Construction Observation Report # 1

Project	Uintah Bybee Water Tanks	Project Number	20218
Location	6393 Bybee Dr, Ogden, UT	Date & Time	02/24/2023 1:30PM
Civil Engineer	Jones and Associates	Weather	Clear
Contractor	FX Construction	Observer	Jami Havens

Construction Observation Report # 2

Photo 1

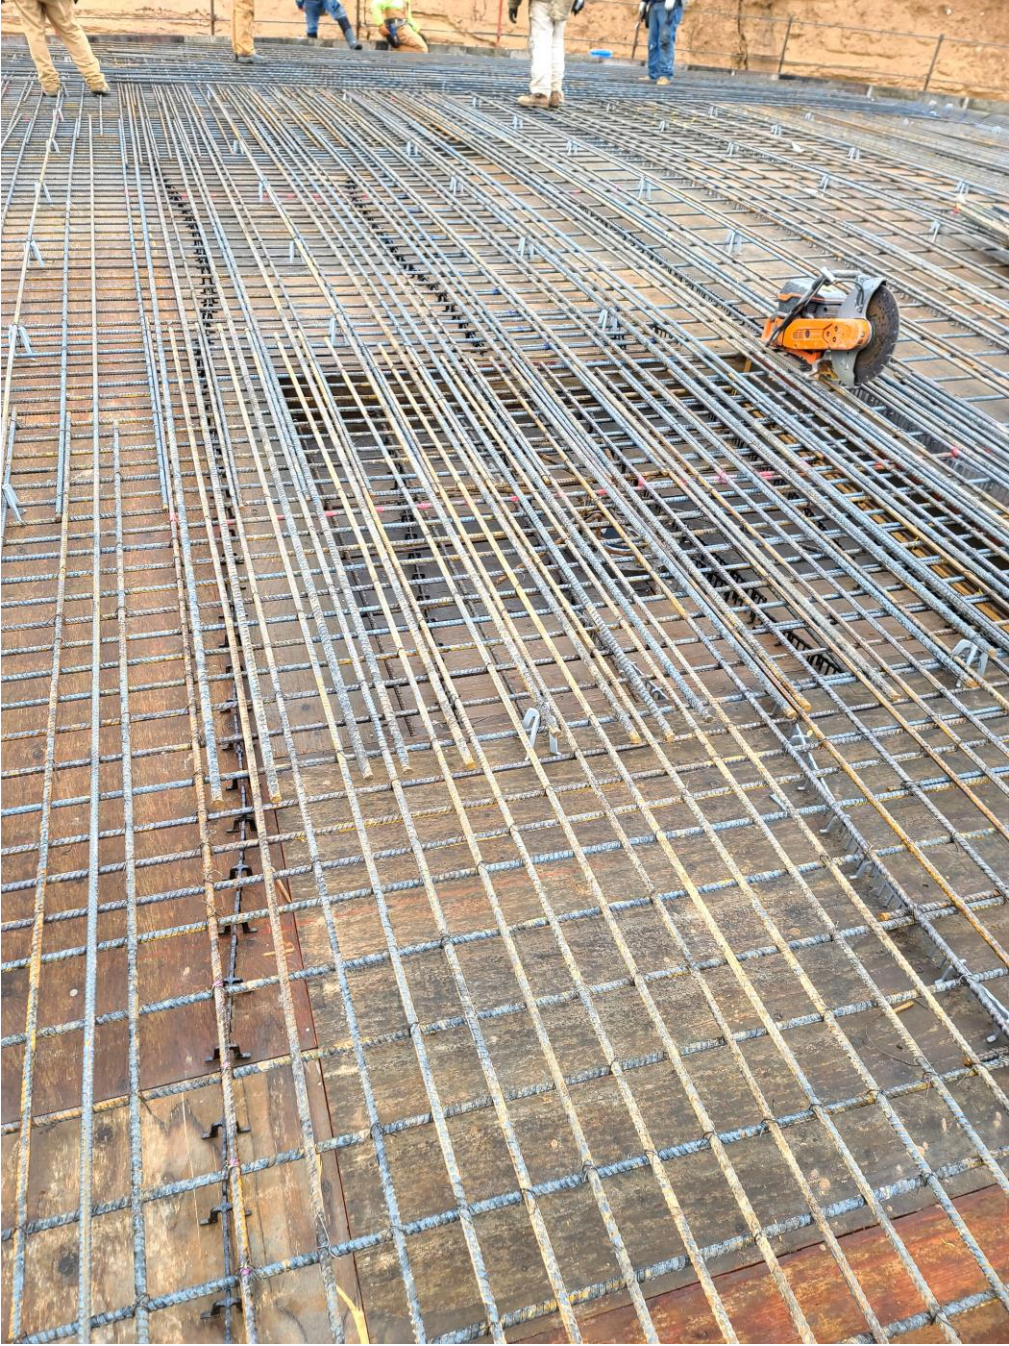
Items of Note:				
Item No.:	Item:	Follow-Up / Action Required:	Initials	Photo:
1-1	The #7 bars in the top layer of the column strips are 1 foot short on each end.	Replace the rebar with the correct length or add additional an additional #7 bar spliced on to each #7 bar that is short. See detail 2/S1 for the required splice lengths.		1
